Addendum No. 3

Re: Mobile Alabama Cruise Terminal
Parking Deck Repairs
Project #CT-009-24

Date: February 20, 2025

4th LEVEL UNDERSIDE REPAIRS
SCALE: 1/16"=1'-0"

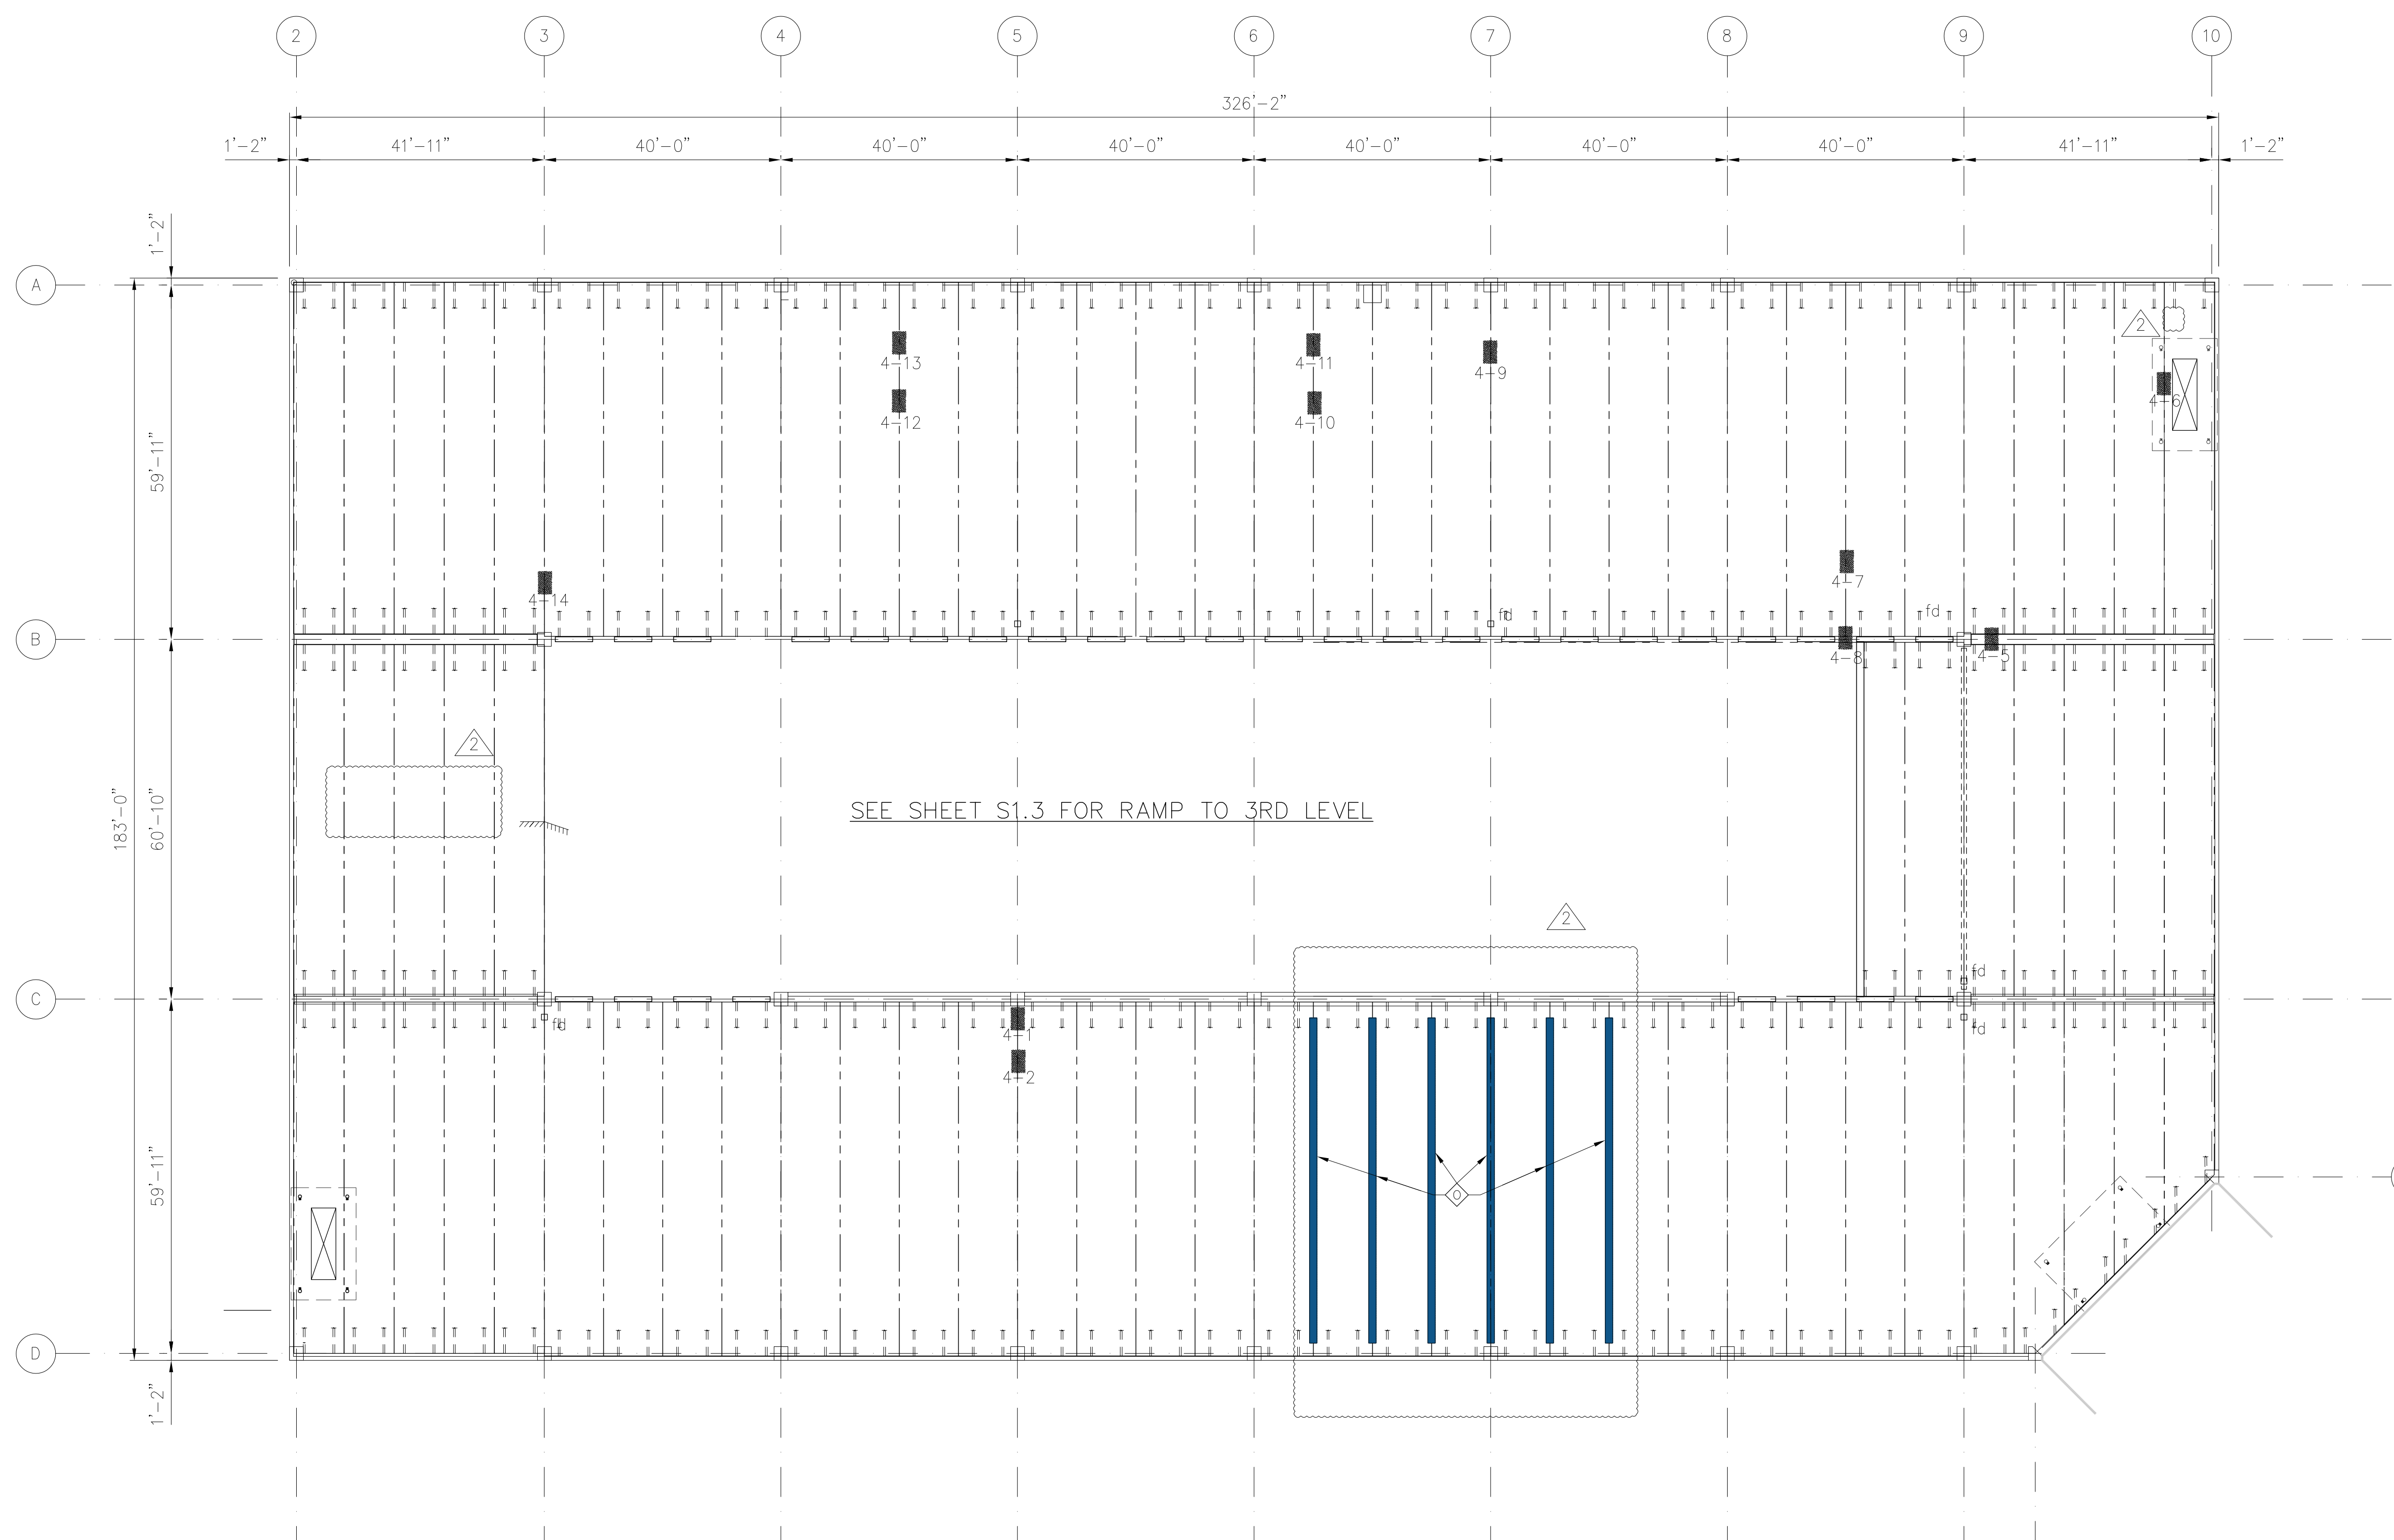
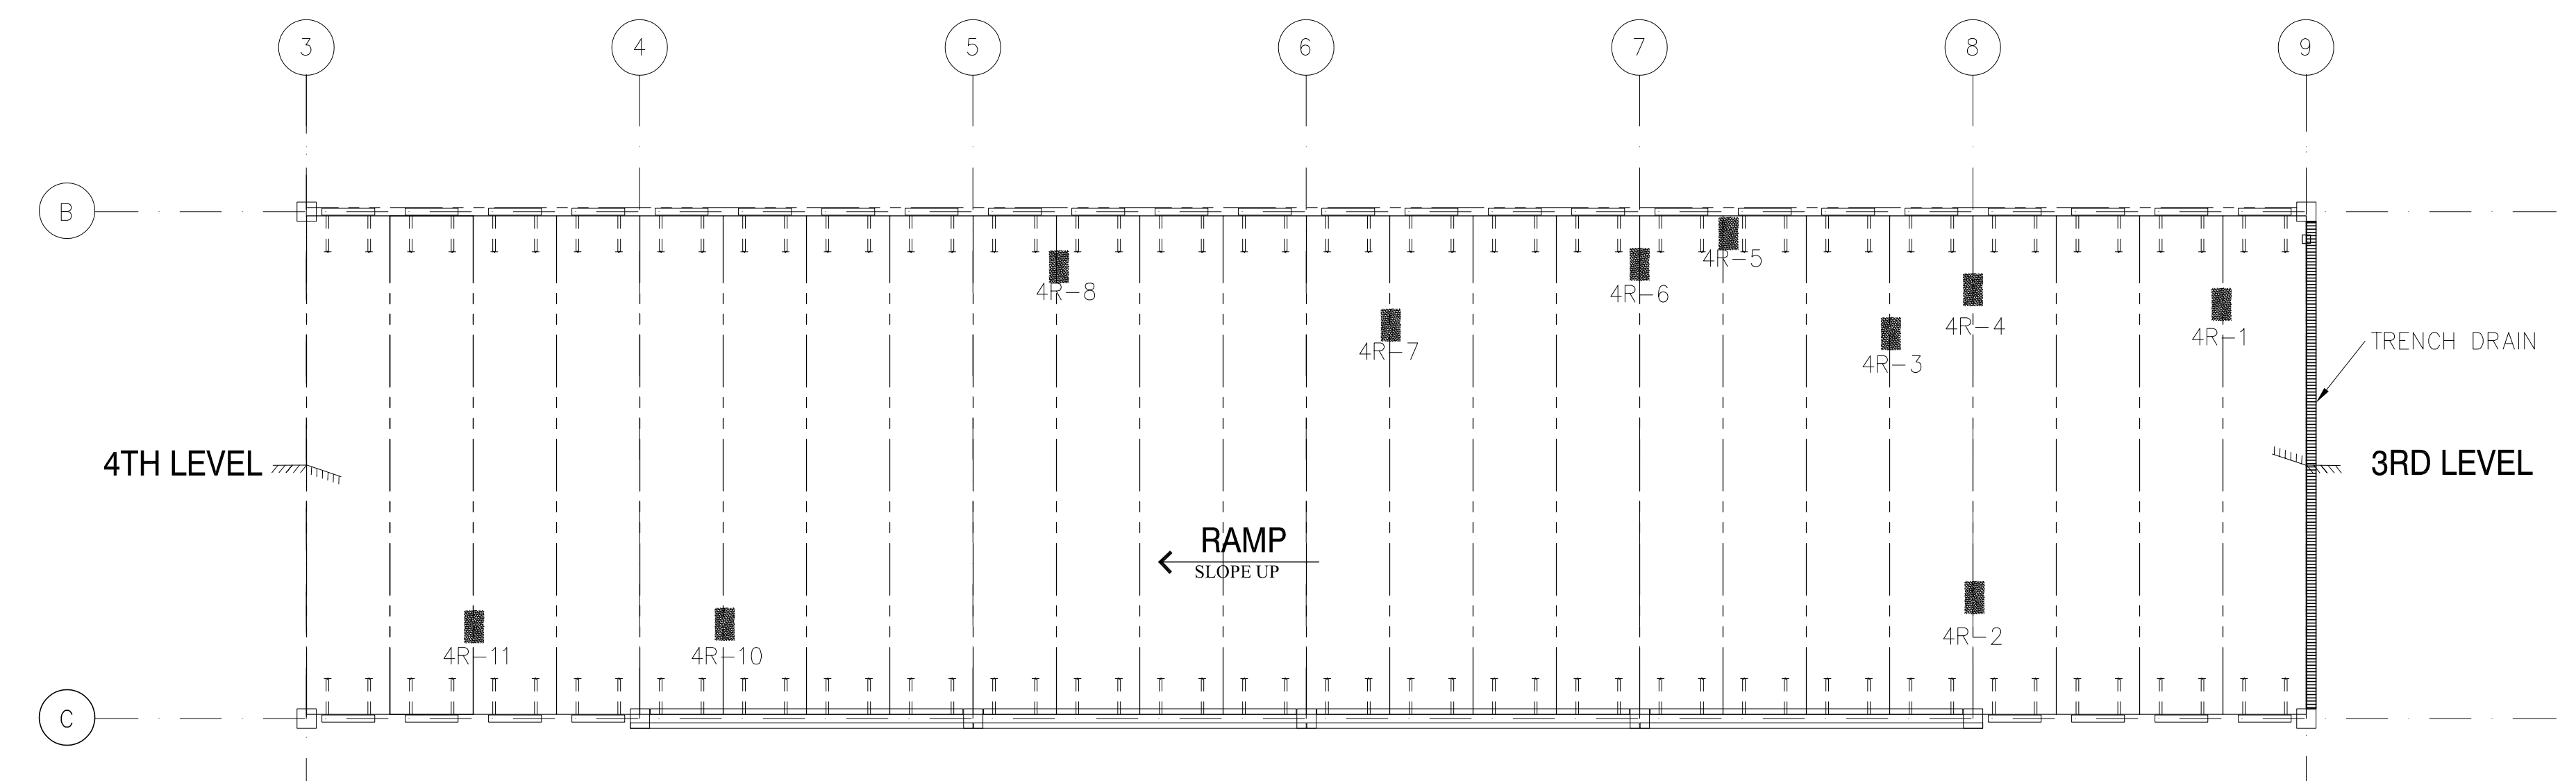
S1.7 4th Level Underside Repair Plan

Item 1 On drawing “4th Level Underside Repairs”, added several areas to repair with Keynote O.

Item 2 Added Keynote O

SECTION 1
SCALE: 1/2"=1'-0" S3.1

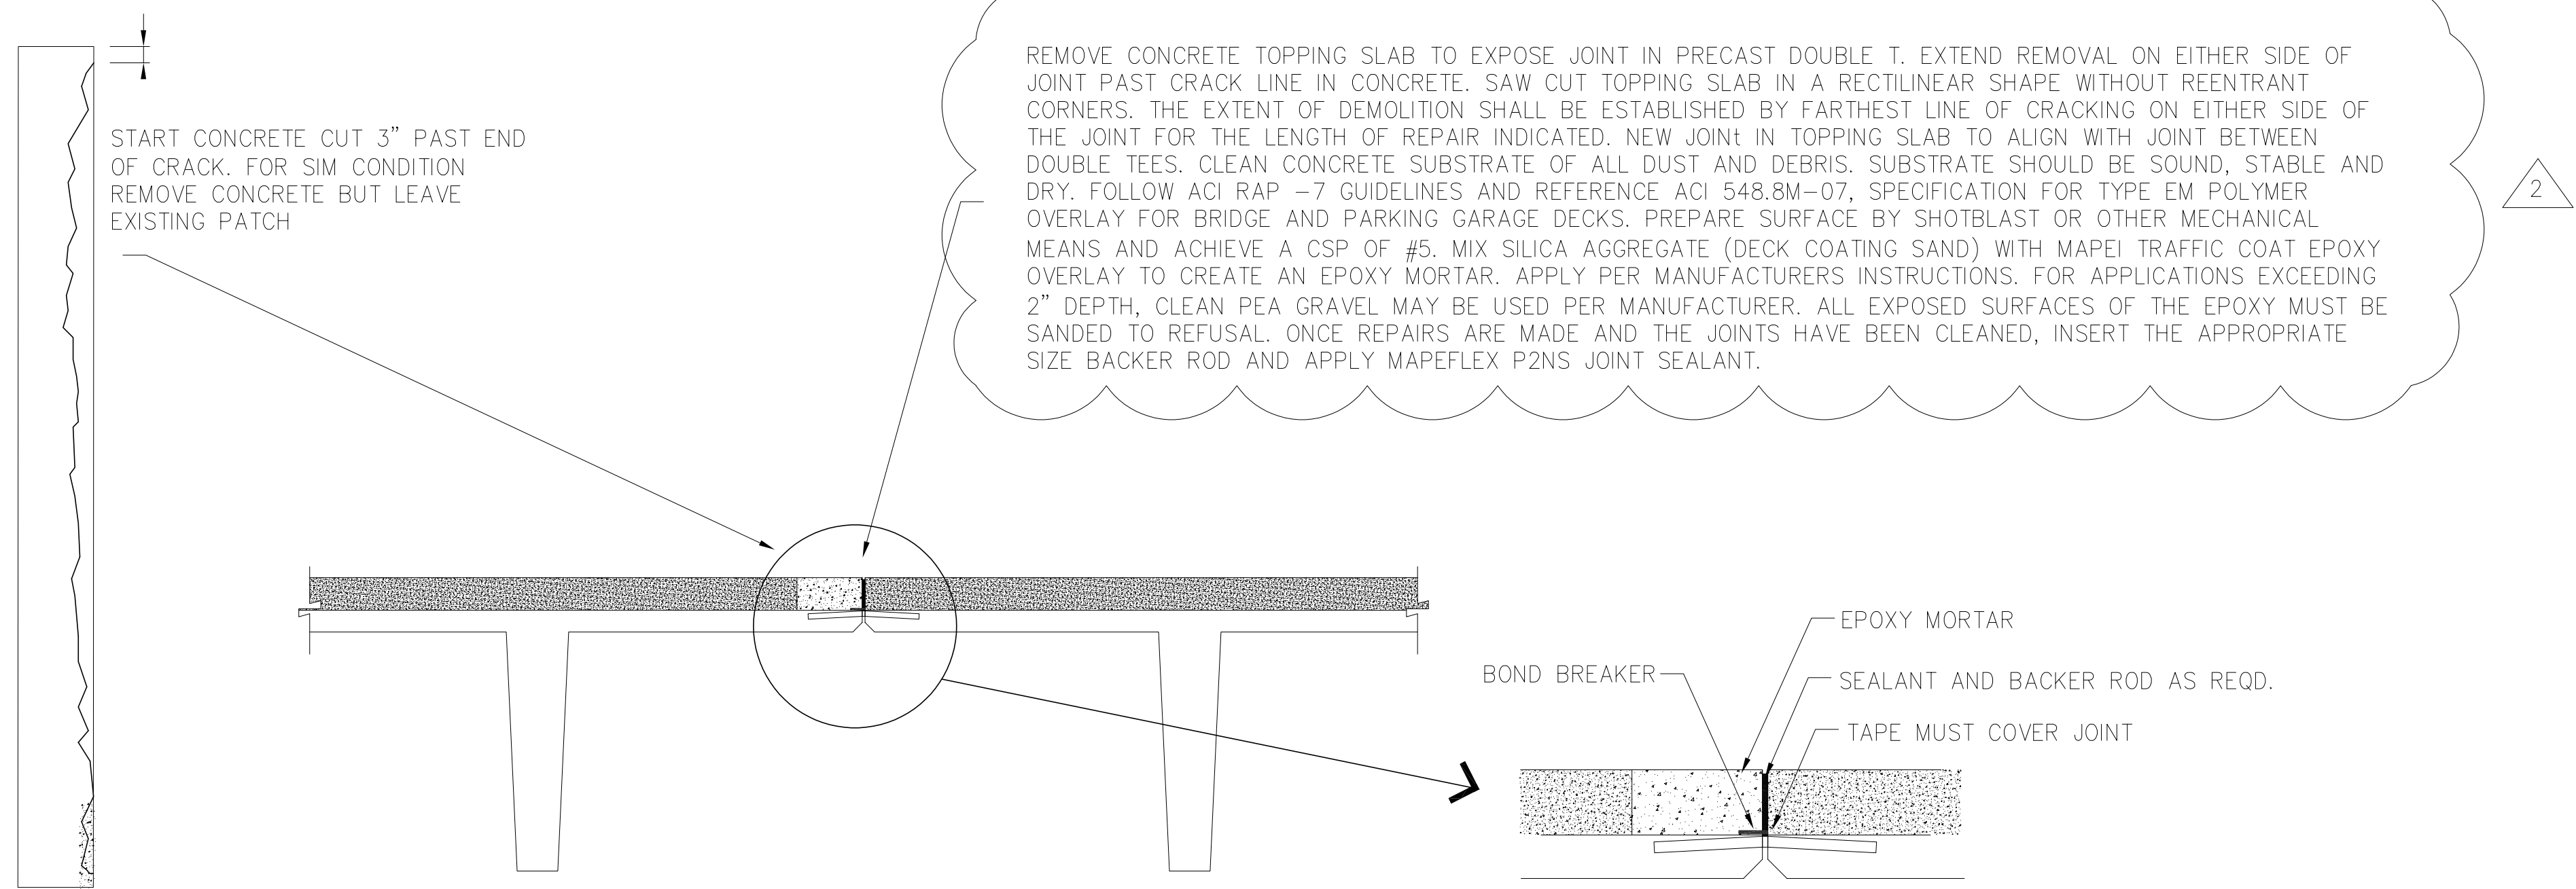
Item 1 Revised Notes on Detail 1/S3.1 as clouded and flagged as Revision #2

SECTION 2
SCALE: 1/2"=1'-0" S3.1

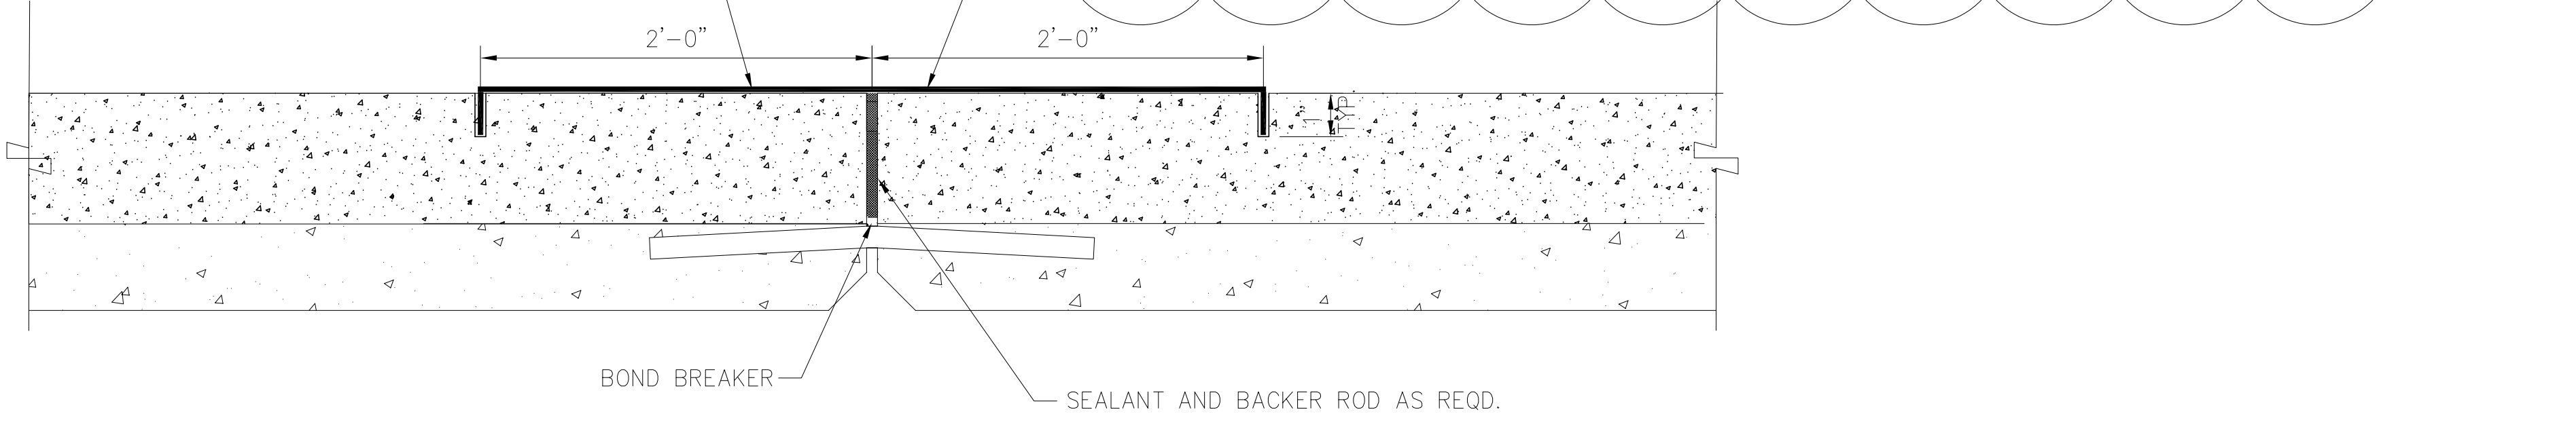
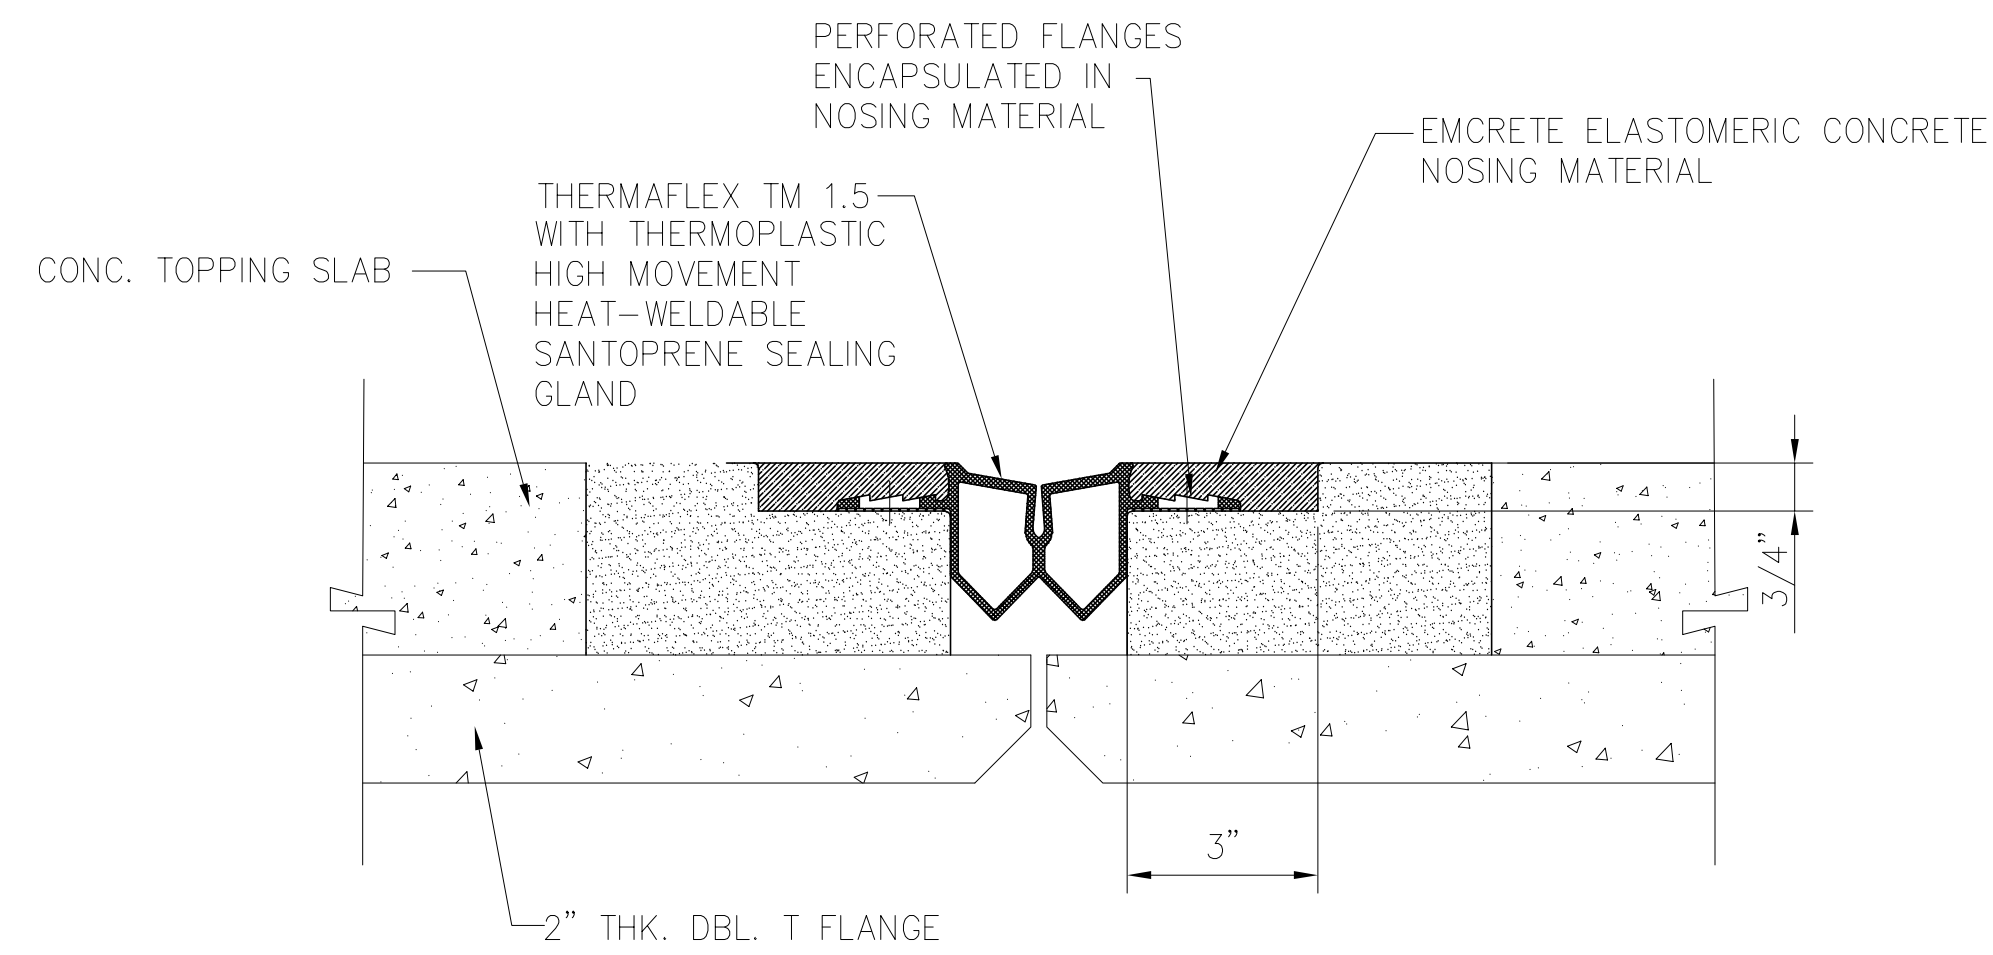
Item 2 Revised Notes on Detail 2/S3.1 as clouded and flagged as Revision #2
